RS-03-209

November 3, 2003

Dresden Nuclear Power Station, Units 2 and 3  
Facility Operating License Nos. DPR-19 and DPR-25  
NRC Docket Nos. 50-237 and 50-249

**Subject: Request for Amendment to Technical Specifications to Add Requirement to Modify Linear Heat Generation Rate Limit During Single Recirculation Loop Operation**

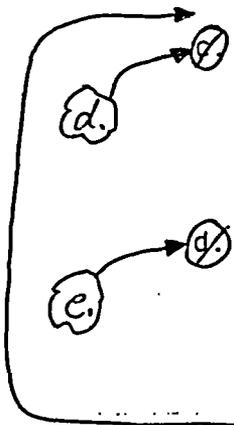
*c. LCO 3.2.3, "LINEAR HEAT GENERATION RATE (LHGR)," Single loop operation limits specified in the COLR;*
